## Application for Licence Amendment

<b>Licence Number</b>	L7750/2001/10
<b>Licence Holder</b>	Evolution Mining (Mungari) Pty Ltd
<b>ACN</b>	002 124 745
<b>File Number</b>	2011/009482-1
<b>Premises</b>	Mungari Gold Project  Legal description –  Part of L15/228, L15/246, M15/688, M15/829, M15/830, M15/1287, M15/1407, M15/1741
<b>Date of Report</b>	22 June 2021
<b>Decision</b>	Revised licence granted

**Figure 1: TRH concentrations with water utilised for dust suppression**

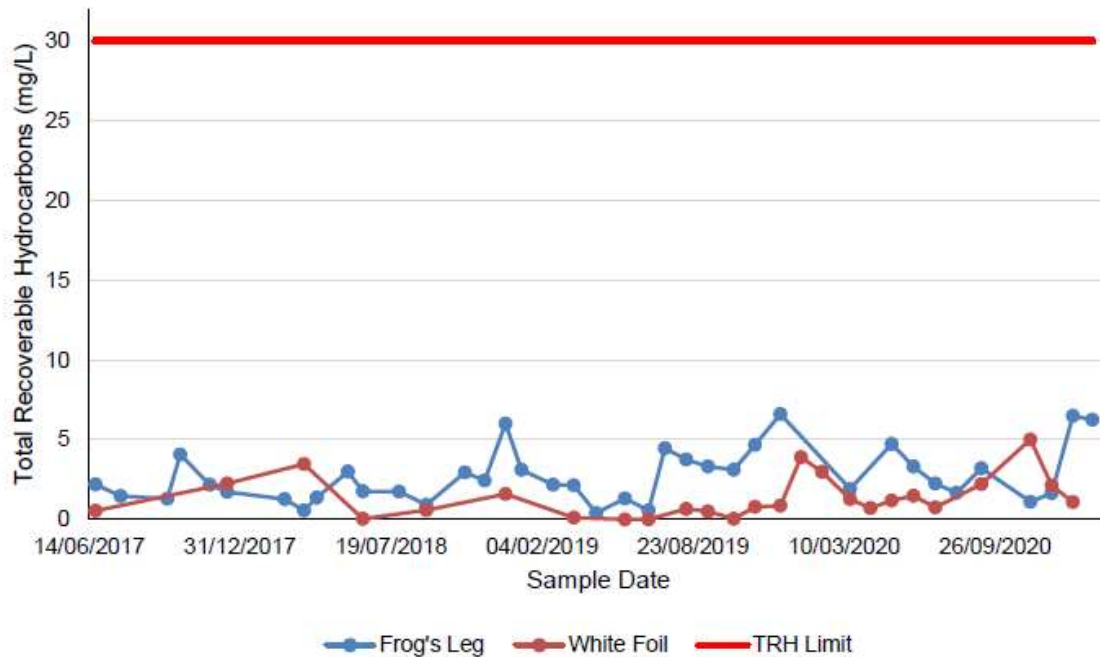
The Licence Holder has requested the removal of the Total Recoverable Hydrocarbons (TRH) limit of 30 mg/L as specified in the existing Licence. In support of this proposed amendment, the Licence Holder has submitted historical data for TRH within water utilised for dust suppression on site, with calculations based on wastewater TRH values once diluted with groundwater prior to being used as dust suppression. The Licence Holder achieves dilution by adding approximately 1,200L of wastewater to a 20,000L water cart. This historical data demonstrates that water that has been emitted to land for the purpose of dust suppression is well below the 30 mg/L specified limit as demonstrated in Figure 1 below.

**Key Finding:** The Delegated Officer has reviewed the supporting information to justify the removal of the TRH limit from the Licence and considers the following:

1. Concentrations of TRH within water to be used for dust suppression have been calculated post dilution, where approximately 1,200L of wastewater is diluted within a 20,000L water tank (approximately 1 part wastewater and 15 parts groundwater, assuming a full tank water tank is used for dilution). It is noted that concentrations within wastewater pre dilution are estimated to be 15 times higher than the presented values, indicating that the current 30 mg/L limit specified in the Licence is being exceeded by almost triple.

To allow for the removal of the TRH limit from the Licence and ensure TRH concentrations in dust suppression water remain low, conditions will be added to the revised Licence ensuring that this dilution factor is maintained during ongoing operations. The intent of added conditions is to reflect current processes in use at the site by the Licence Holder.

As the Licence Holder has demonstrated that historically TRH concentrations within water discharged to land through dust suppression have been well below the specified limit, these maps are not required on the Licence and will be deleted through this

Figure 2: Proposed crushing and screening locations

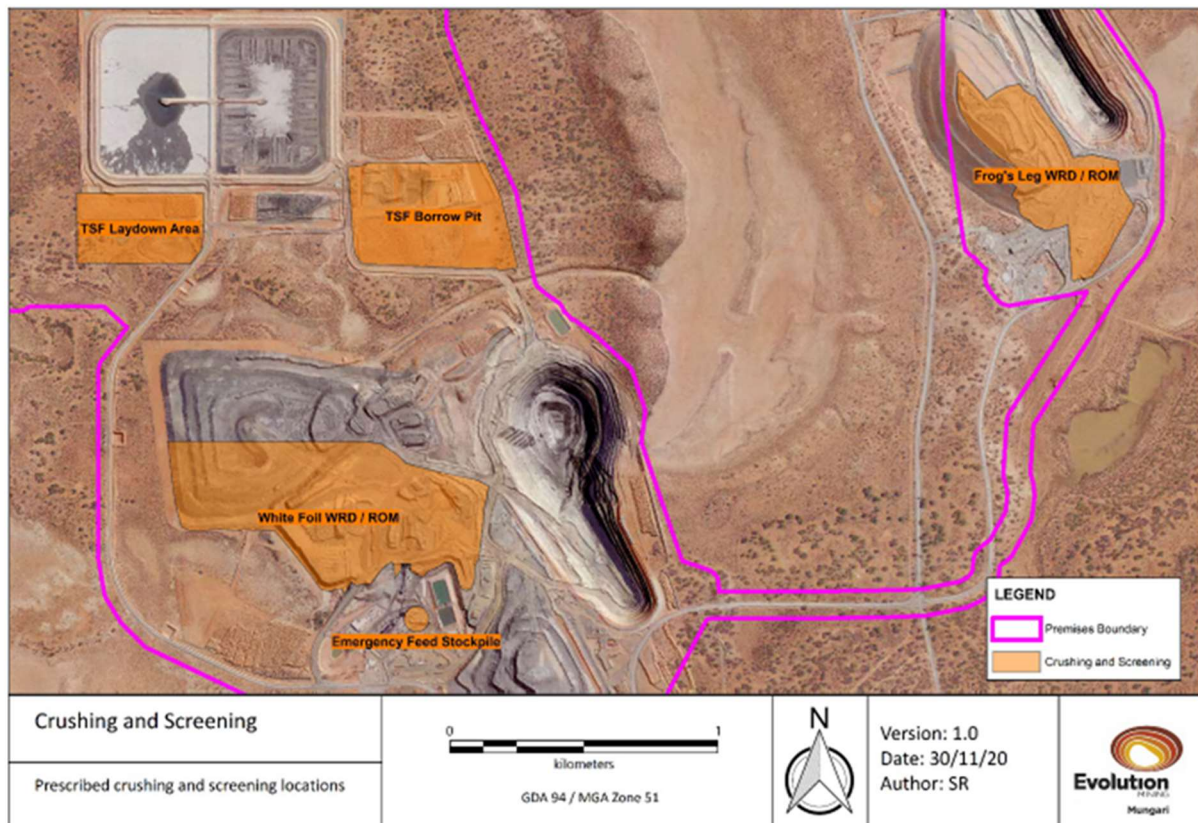
The Licence Holder is seeking the inclusion of Category 12 on the Licence to authorise mobile crushing and screening activities at the site. Material will be crushed to varying sizes between 5 mm to 300 mm and will be used for road construction, stemming for open pit and underground blasting operations, and emergency mill feed. The plants annual throughput is anticipated to be under 500,000 tonnes. As the exact location of crushing and screening activities will be variable depending on source rock properties and operational needs, the Licence Holder proposes to conduct crushing and screening activities within the boundaries indicated in Figure 2 below.

**Figure 3: Proposed landfilling locations**

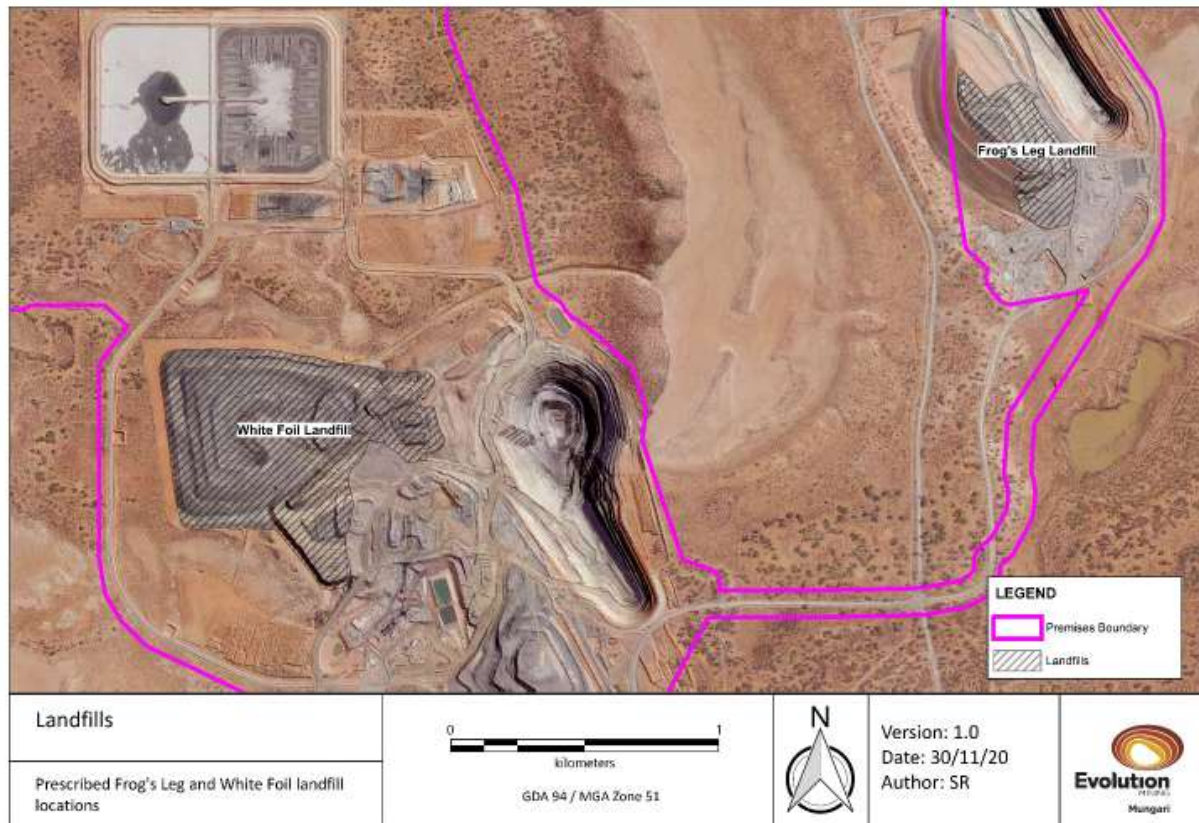
The Licence Holder is seeking to expand the areas that are currently permitted for landfilling within the White Foil and Frog's Leg waste rock dumps (WRD) on the existing Licence, so that the entire area of both WRD's can be utilised for landfilling purposes. These areas are outlined in Figure 3 below. No change to the current Category 89 throughput, landfill management practices or the waste types accepted to landfill are proposed, however the Licence Holder requires greater flexibility regarding where landfill trenches can be constructed to accommodate for the mining schedule at the site. Landfill location will move in line with the construction of the waste dumps, which will ensure that all trenches will eventually be incorporated into the final profile of the landform.

**Key Finding:** The Delegated Officer notes that current conditions within the existing Licence do not clearly reflect permissible accepted waste types or waste processing requirements.

Licence conditions will be amended to provide greater clarity to the Licence Holder regarding their waste acceptance and processing requirements.

**Figure 4: Historical timeline of non-compliant TSF monitoring bores**

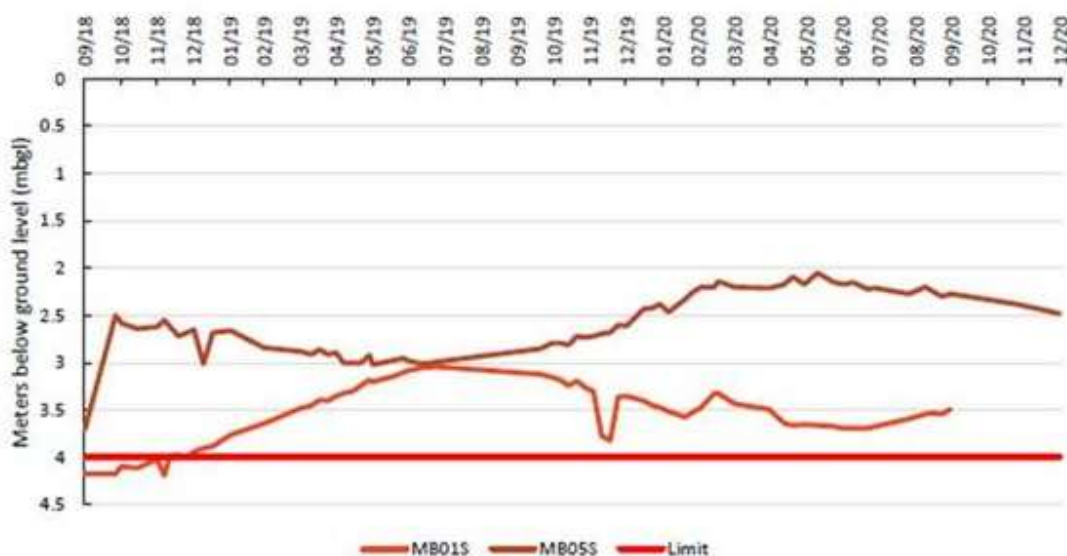
Continued monitoring of MB05 has indicated that these mitigation measures have done little to reduce groundwater mounding and prevent the subsequent limit exceedance of the SWL. However, no increase in the SWL within MB05 has been noted since mitigation measures were implemented, with SWL fluctuating between 3 mbgl and 2 mbgl as indicated in Figure 4 below.

**Key Finding:** The Delegated Officer considers the presence of a 10m deep dry bore 50m north of MB05 presents a good indication that groundwater mounding is limited to an area immediately surrounding the TSF.

Noting that the SWL of MB05 has historically exceeded the current licence limit of 4 mbgl, a new SWL limit for MB05 will be introduced to the licence of 2 mbgl. This limit has been deemed appropriate based off historical SWL data that has been submitted to DWER for MB05 and ensures that any significant increase to the SWL of MB05 is reported to DWER in line with the N1 reporting requirements specified on the Licence.

Since groundwater mounding has been confirmed to be present surrounding the TSF, the Delegated Officer also deems it appropriate to include the requirement for annual vegetation monitoring on the Licence specific to this area. This monitoring aims to provide additional assurance that groundwater mounding is localised to the TSF surrounds and is not impacting nearby vegetation.
